ADDENDUM NO. 4

DATE: December 6, 2022
FROM: City of Grand Junction Purchasing Division
TO: All Offerors
RE: IFB-5134-22-DD 2022 24 Road Multi-modal Path Construction
CDOT Project No. MTF M555-035 (24077)

24 ROAD BIKE PATH
TABULATION OF QUANTITIES
December 5, 2022

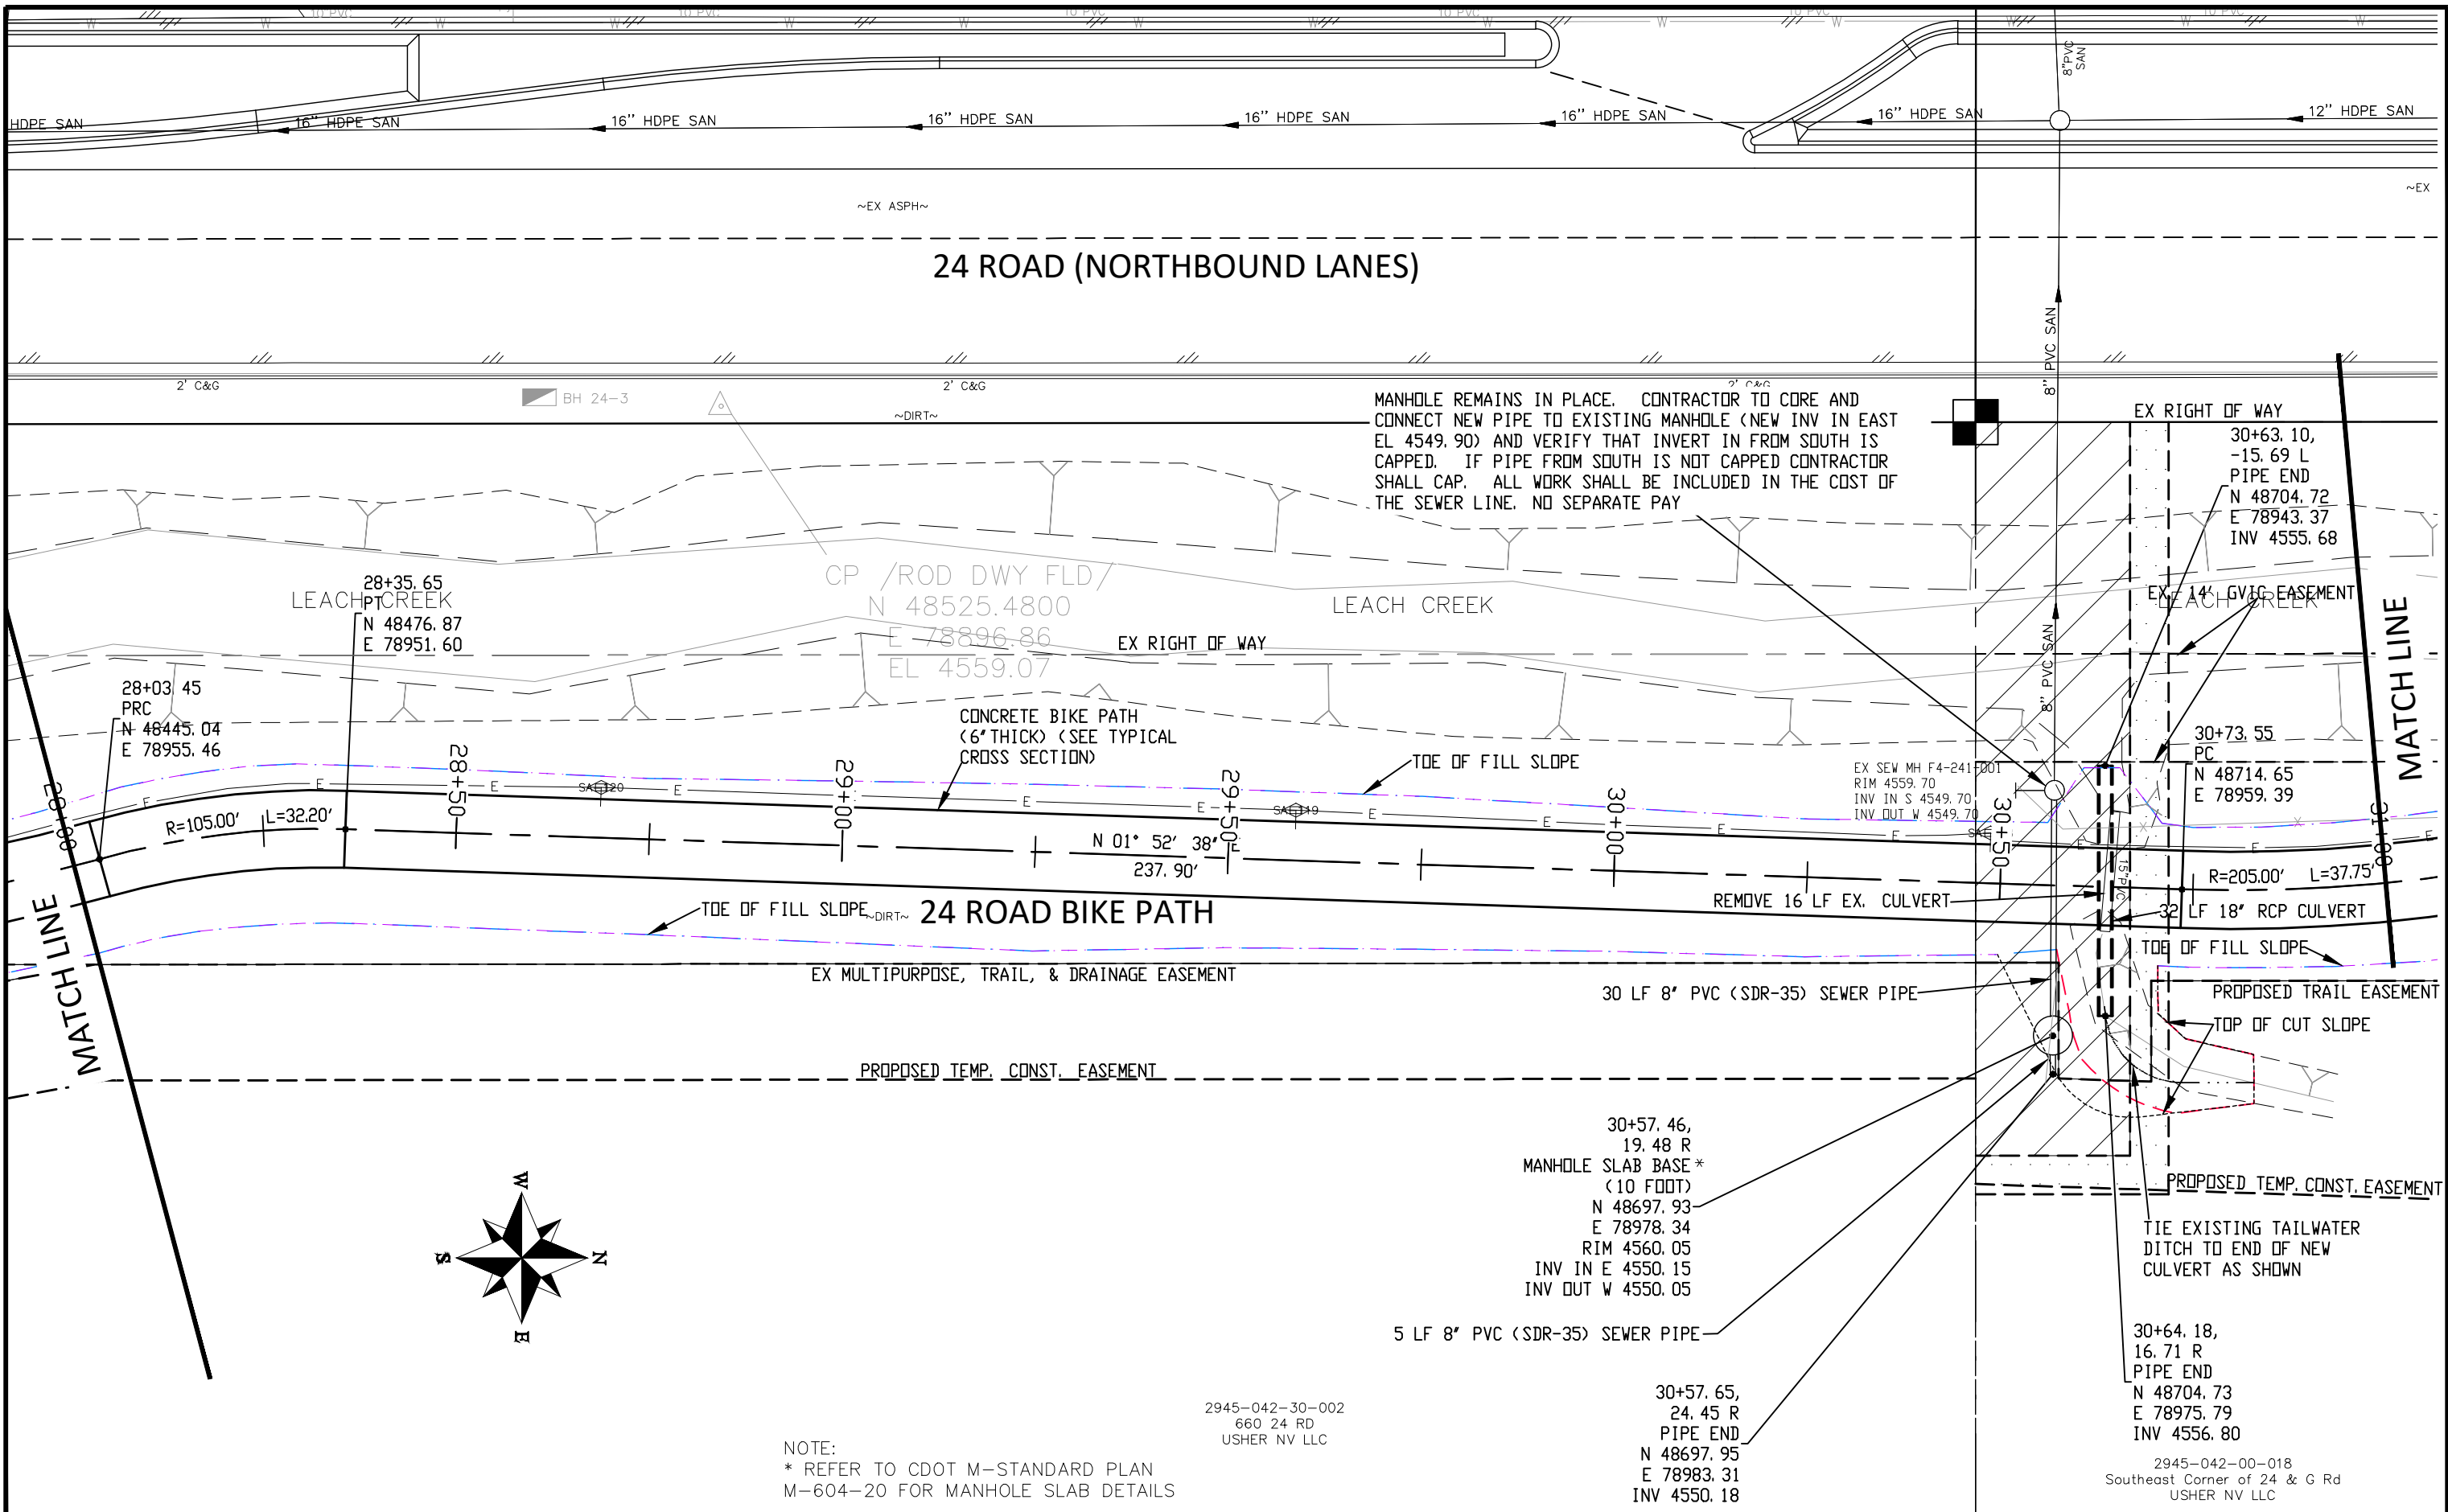
2. **Question:** The Concrete Bench Pads shown on Sheet 14 of 16, will this be paid with the Bike Path in item 31? If not, will the Owner provide a pay item for the bench pads?

3. **Question:** Item 29, please confirm this item pays for the manhole and the manhole base.
Answer: Yes, please refer to CDOT M-Standard M-604-20 for precast manhole details. Item includes manhole and manhole base. (**See Attached Revised Page 12 of Appendix D with Corrected CDPT M-Standard**)
Revised Pages Appendix D <http://trimview.gjcity.org/?=SOLDOC/25148>

Answer: The Concrete Bench Pads shall be paid utilizing the "Concrete Bikeway (6 inch)" item. (**See Attached Revised Bid Schedule and Revised Page 6 & 7 of Appendix D with Corrected Quantity**)
Revised Bid Schedule <http://trimview.gjcity.org/?=SOLDOC/25147>
Revised Pages Appendix D <http://trimview.gjcity.org/?=SOLDOC/25148>
